CLL Application For Permit Amendment No. 6 - M1977300

Re: Schwartzwalder Mine – File No. M-1977-300, Colorado Legacy Land, LLC –
Amendment Application (Amendment 6)

Denver Water is submitting its written comments in response to the Application Amendment 6 for mine permit M-1977-300 (“Amendment 6”) submitted by Colorado Legacy Land LLC (“CLL”) concerning the Schwartzwalder Mine in Golden, Colorado. For the reasons discussed below and in the three enclosed technical memoranda, the Division of Reclamation, Mining and Safety (“DRMS”) should deem Amendment 6 deficient and require CLL to supplement with additional information. Denver Water further requests that DRMS increase CLL’s financial warranty due to the inability of CLL to stabilize the mine pool chemistry with its current method of operation.

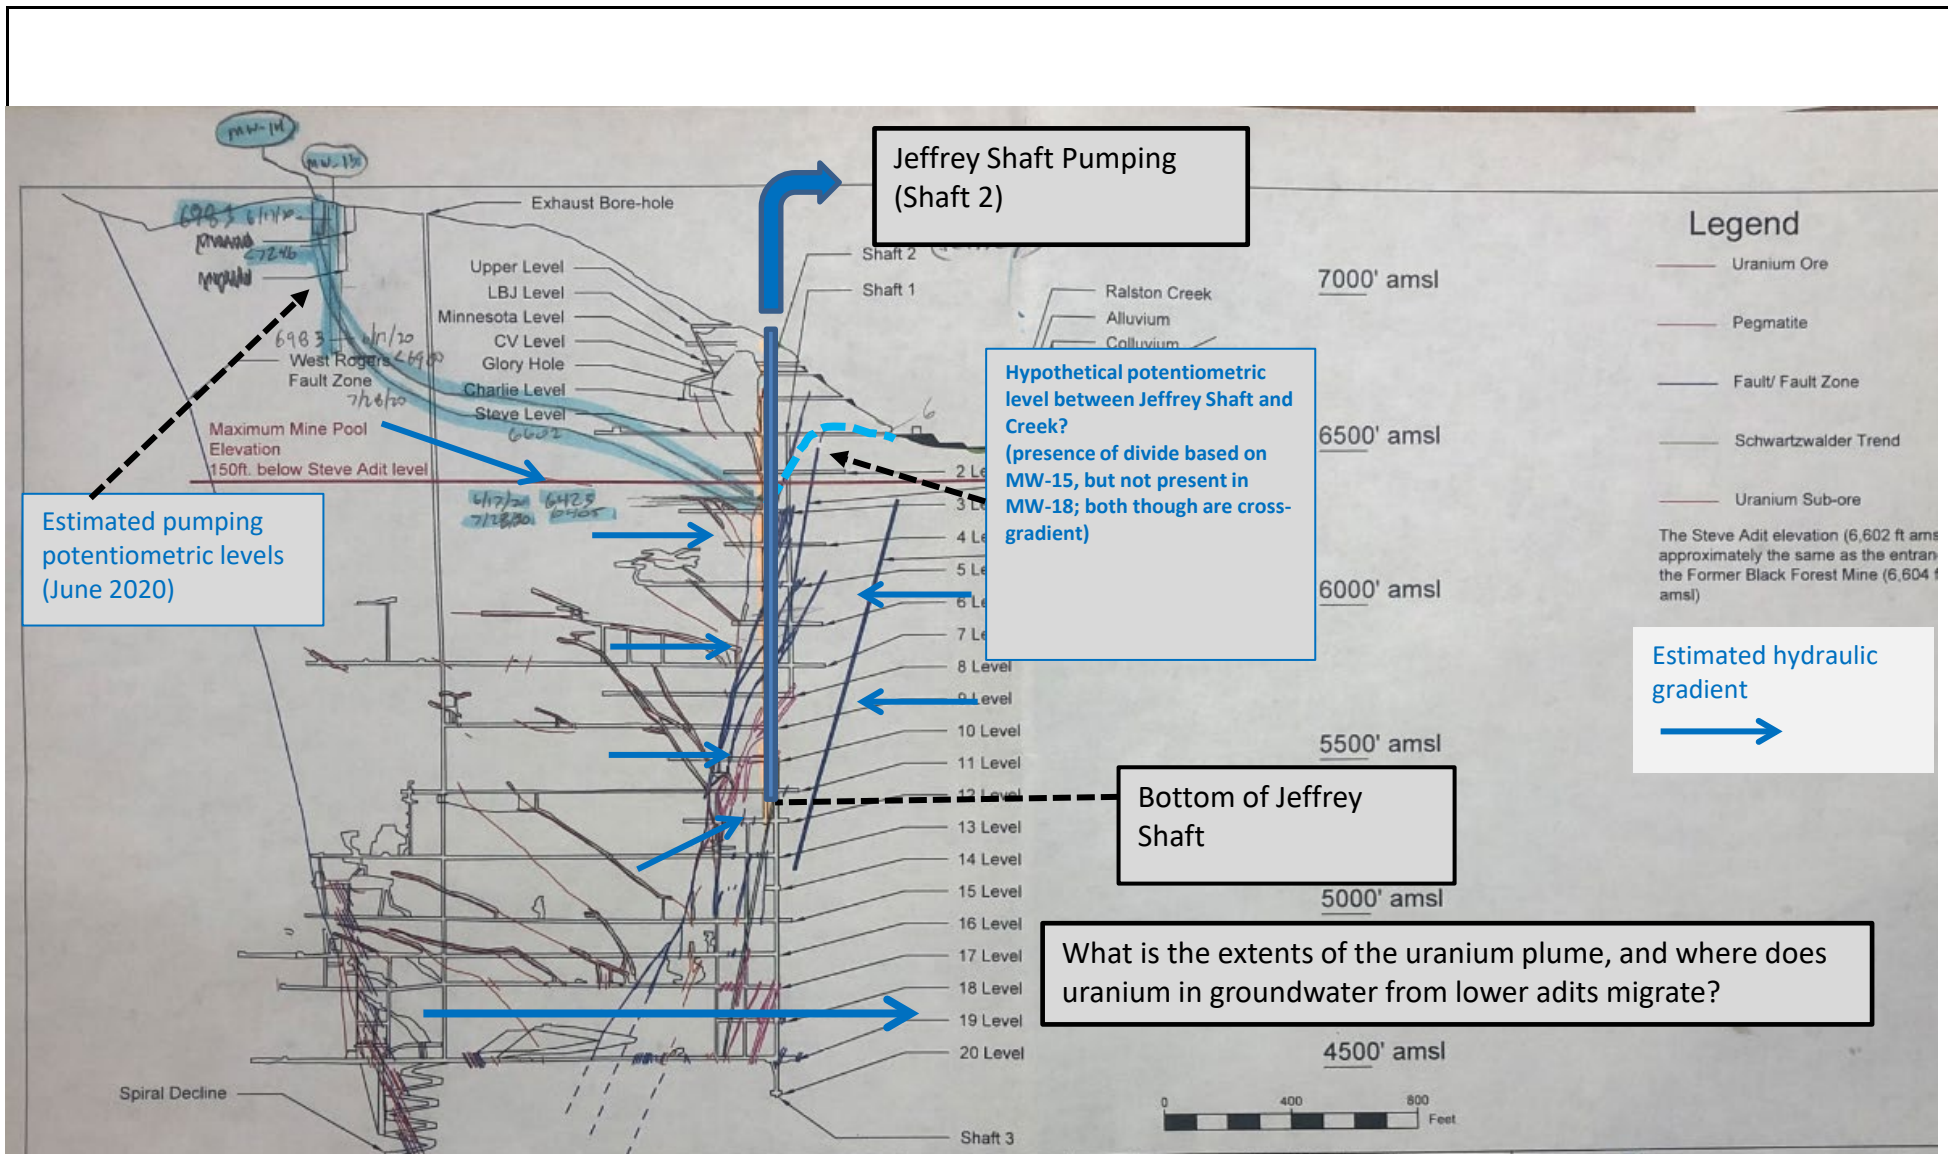
below Steve Level Adit. This is another example of data that were collected and should be included in the CSM. This hydraulic (and therefore contaminant) gradient assumes that pumping in the mine pool will continue in perpetuity; however, this assumption is not stated in the preliminary CSM, conceptual considerations, or within the reclamation plan. Therefore, according to ASTM Standard Guide Section 6.5 Identifying Migration Pathways, if pumping does not continue in perpetuity future releases and migration of the contaminants along all complete potential pathways should be modeled.

Furthermore, as stated in the memo addressing physical and chemical stabilization of the mine pool, data presented are insufficient to assert that an inward bedrock groundwater gradient has been established for all areas of the uranium plume in bedrock groundwater. CLL uses only two bedrock monitoring wells, one of which only has three data points dating to Q2 2020, and both of which are essentially cross-gradient.

In addition, Figure 2 depicts an estimate of the bedrock mine pool pumping capture zone based on the bedrock groundwater elevations. Since CLL has described the pumping capture zone as anisotropic, additional bedrock groundwater elevations and more bedrock groundwater wells (particularly within the permit boundary immediately east/northeast of the mine pool pump and southwest of Ralston Creek) would be necessary to demonstrate an inward groundwater gradient towards the mine pool.

- Provide two figure/diagrams depicting the delineation of potential migration pathways from the mine pool through bedrock groundwater, and other fractures or faults such as the Illinois Fault Zone. An example of a cross-section is shown in **Figure 1**.

- This diagram should continue to be updated as data is collected.
- Prepare two figures in plan view depicting the potentiometric surface of groundwater at different pumping conditions in the mine pool (e.g. at 150 ft below Steve Level Adit and at 325 ft below Steve Level Adit), similar to **Figure 2**, to demonstrate that 150 ft below the Steve Level Adit is adequate for maintaining an inward hydraulic gradient from Ralston Creek to the mine pool.

- Add an additional groundwater monitoring well downgradient of the mine pool to refine the potentiometric surface. A recommended location is also depicted on Figure 2.

Figure 1

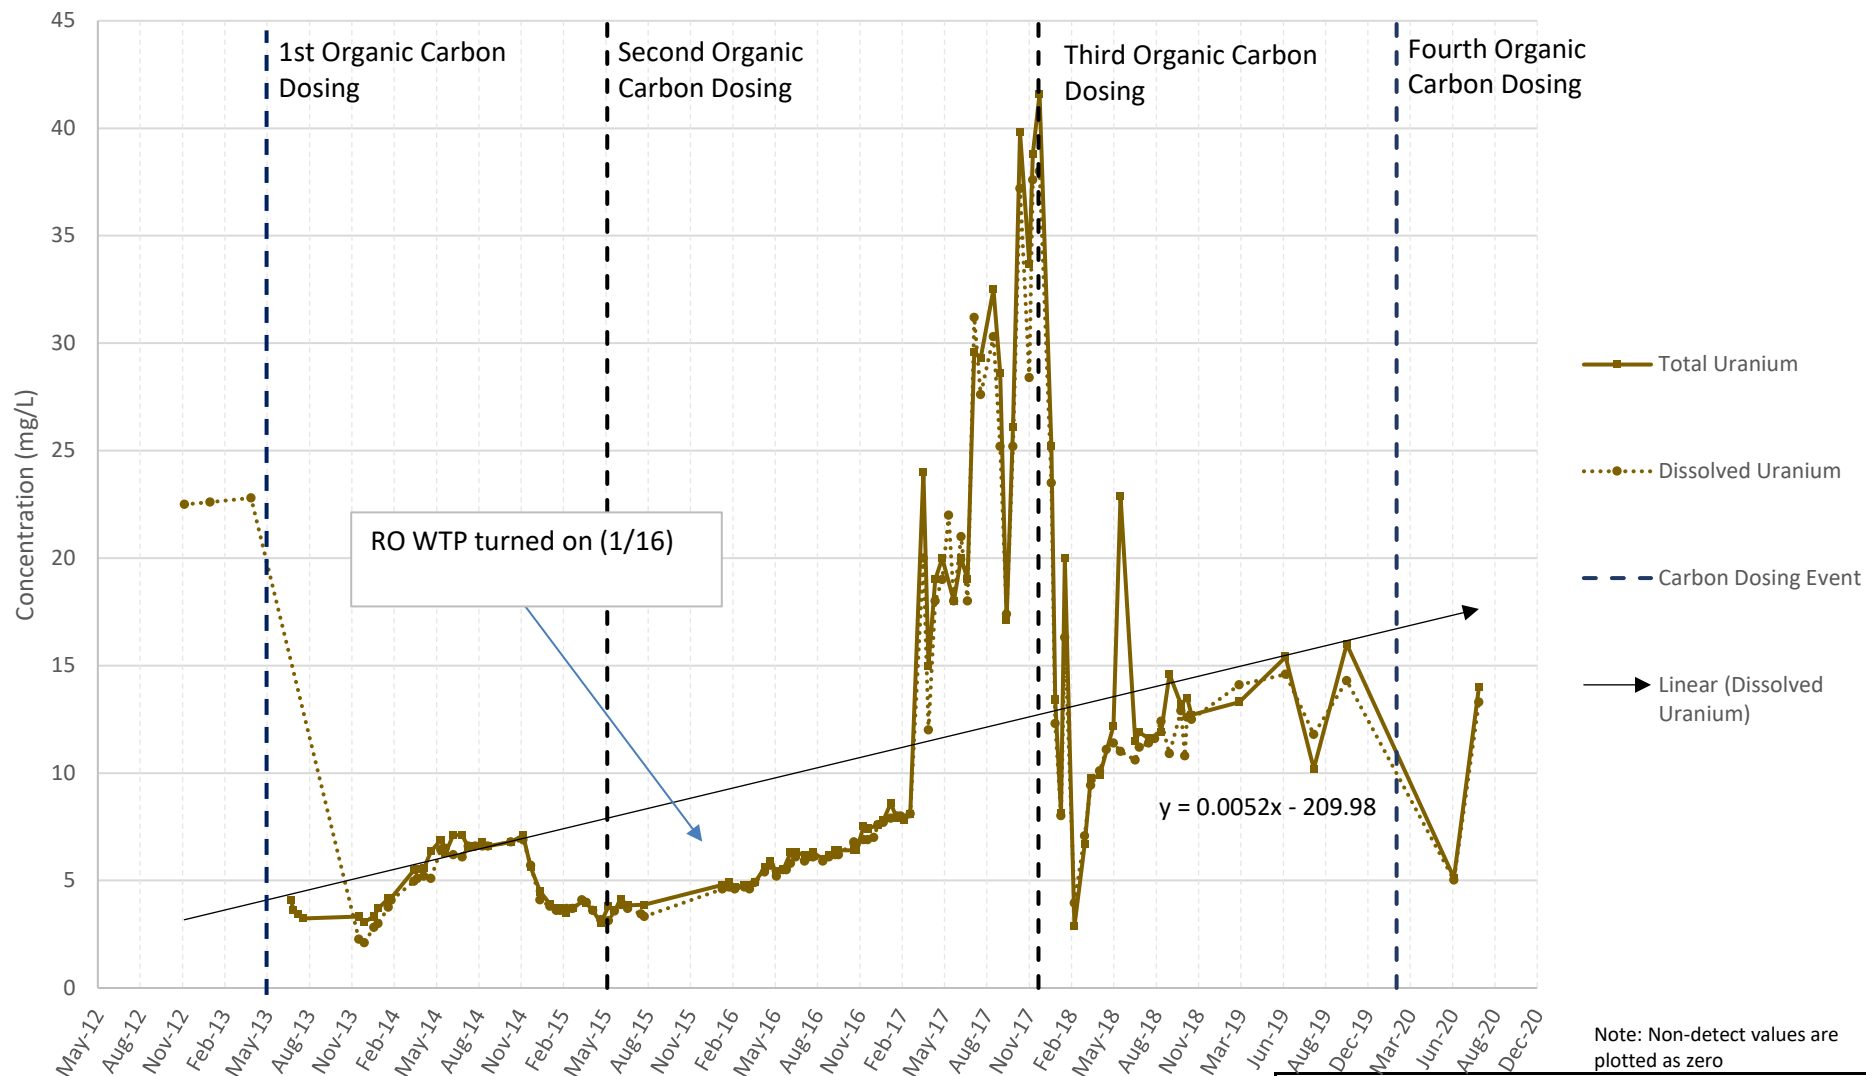
CLL does not provide sufficient data to assert that an inward bedrock groundwater gradient has been established. CLL uses only two bedrock monitoring wells, one of which only has three data points dating back to Q2 2020. This does not demonstrate physical stabilization of the mine pool for the last three consecutive years, as required by the SO-1 approval letter. This is an important condition when considering the conditions for updated reclamation costs.

Although there are a limited number of bedrock monitoring wells which can be used to draft potentiometric contours, an estimate of the mine pool pumping capture zone based on the existing bedrock groundwater elevation (potentiometric) data is shown in **Figure 1**. Capture zone estimates are typically drawn in plan view and cross-section to fully illustrate the area in which inward hydraulic gradients exist due to pumping. Although CLL has demonstrated inward gradients based on two wells cross-gradient to the pumping area (MW-15, MW-18), they have not illustrated the capture zone relative to the mine workings or permit boundary. In Section E.5.1 (p. 15) CLL
